# Access Compliance Report Public Rights-of-Way (Curb Ramps)

Intersection ID: 53960	Main Street: DENBUR_DR	Cross Street: MAGNOLIA_LILY_AV	Location: SE
ADA ID: EF9ED284A31E	Ramp Type: Combination2	Initial Pass/Fail: Fail	Overall Compliance: No Severity Score: 10

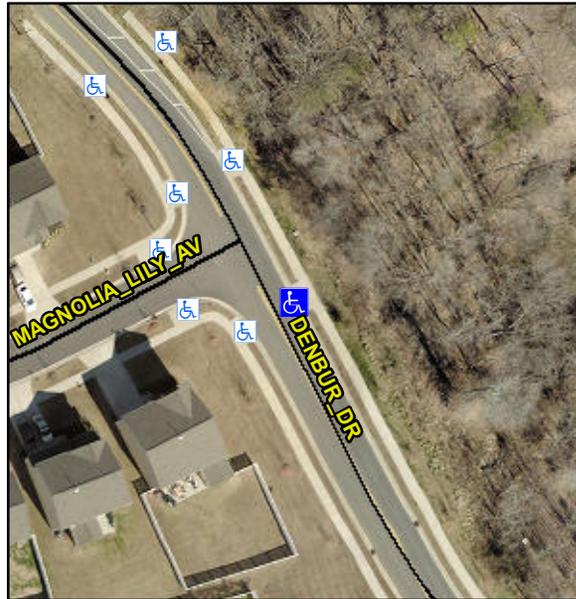
**RT RP < 5%**

**Not Found, R304.5.1, R304.5.3**

**Remove & Replace Entire Ramp.**
